June 20, 2017 Staff Report to the Municipal Planning Board

CASE #ZON2017-00010 Item #9

EAST PARK PD AMENDMENT

Updated: June 9, 2017

Proposed PD Master Plan

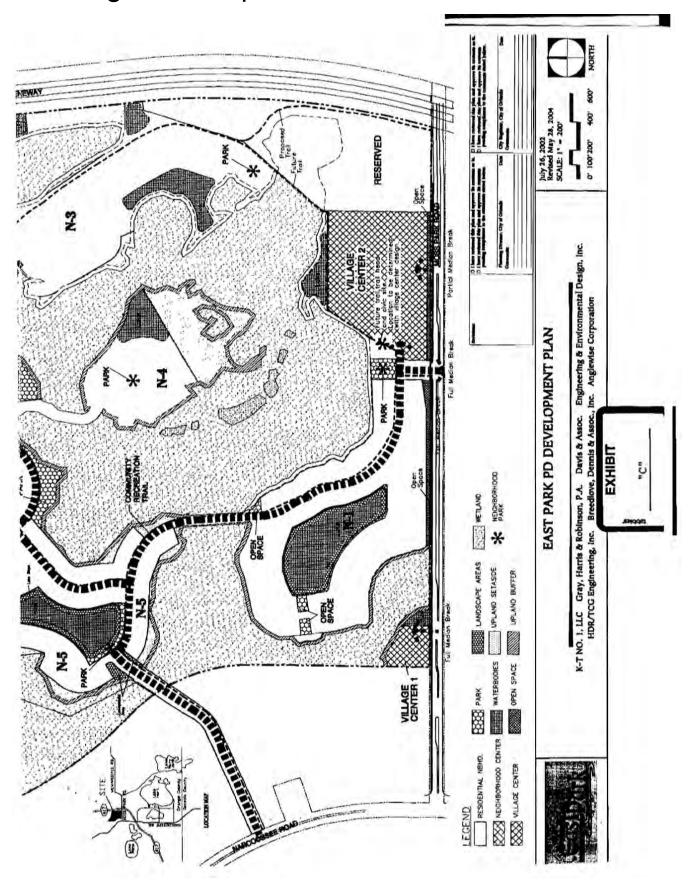
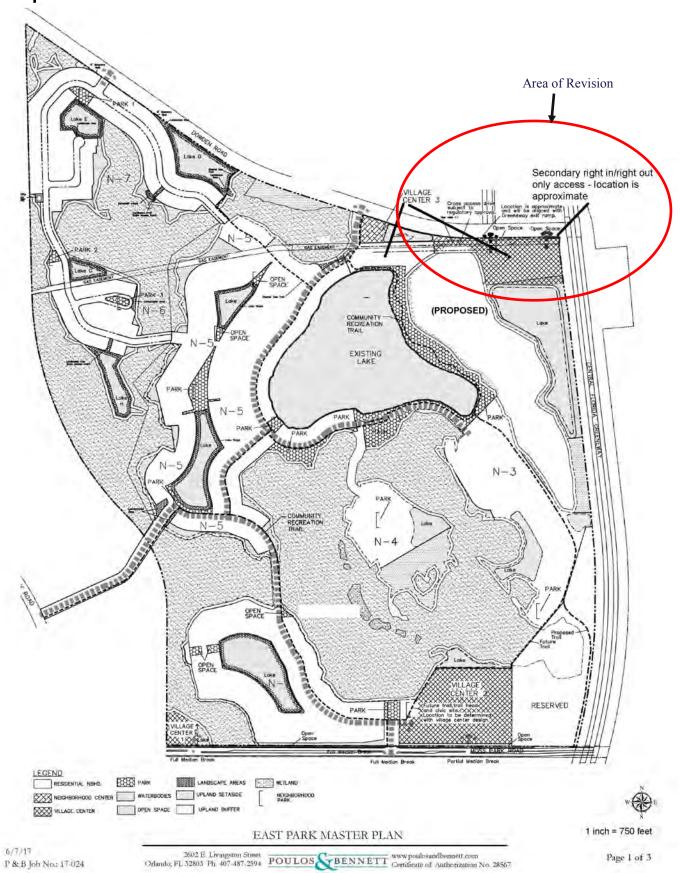
Proposed Amendments

- Amend the PD Master Plan map to identify Village Center 3.
- Amend the Village Center table to reflect the new acreage and development program for Village Center 3.

- Amend the Overall Development table to reflect the new acreage for the Village Center (20.70 acres 31.84 acres) and Residential Neighborhoods (155.08 acres 144.08 acres) categories.

- Amend the Residential Neighborhoods table to reflect the updated maximum residential neighborhood units (1093 818) and the maximum total project units (1100 899)

- Development Data Notes 1-6 and 8 have no changes.
- Development Date Note 7 and 9 were amended in the following way, <u>underline</u> denotes new text and strikethrough denotes deleted text.

- 7. For the purposes of determining school capacity, 1100 units are conceptually agreed to although the developer (K-T No.1 LLC) is certain that the OCPS memo dated November 18, 2003 is in error and that the actual unit number agreed to was 1233. The developer reserves the right to retain 1233 units if there are significant detrimental changes required to the plan and terms as proposed on this revised plan dated May 24, 2004. If greater than 110 units are proposed, a PD amendment with school capacity/concurrency assessment to address the incremental increase is required.

- 9. Village Centers 1, 2, and 3 may increase non-residential square footage provided usage does not exceed a cumulative maximum of 200,000 square feet as supported by the Traffic Study dated May, 2004 prepared for and part of the record of the Third PD Amendment. Village Center 2 shall not exceed 9,184 daily trips as calculated using the methodology in the Traffic Study dated May 2004 and the Village Center 2 Master Plan (MPL2007-00011). Village Center 2 and 3 may convert between office, retail and residential uses (up to a maximum of 1100 dwelling units in the PD) if a trip equivalency calculation consistent with the above methodologies is included in a Specific Parcel Master Plan. If additional trips are proposed, a PD amendment with traffic study to address the incremental increase is required.

- 10. Non-residential uses within Village Center 3 may exceed the maximum parking allowed by Chapter 61 of the Land Development Code. The specific parking allowance shall be approved through a Specific Parcel Master Plan application.

- General Notes 1, 4-8 have no changes.
- General Notes 2a, 2b and 3 were amended in the following way, <u>underline</u> denotes new text and <u>strikethrough</u> denotes deleted text.

- 2a. Consistent with GMP Future Land Use Policy 4.1.9, within the Village Center component of this project, the

land use and building standards found in the Conventional LDC shall apply to all non-residential development less than 0.4 FAR and to residential development less than 25 du/gross acre. Such development shall be consistent with the City's AC-1 zoning district, with the FAR exceptions noted above. Any proposed development equal to or greater than the above-mentioned densities and intensities shall be subject to the land use and building standards found in the LDC Chapter 68.

- 2b. Within the Village Center components of this project, the land use and building standards found in LDC Chapter 68, particularly Figure 68-C, shall apply.
- 3. Roads, stormwater ponds, parks and land uses show on this Plan are conceptual and will be defined in greater detail on Specific Parcel Master Plans for each Residential Neighborhood and on the Preliminarily Plat.
- · General Note 17 is new text.
 - 17. Village Center 3 may be developed in multiple phases. A Specific Parcel Master Plan shall be submitted for each phase to provide a review of the proposed development.
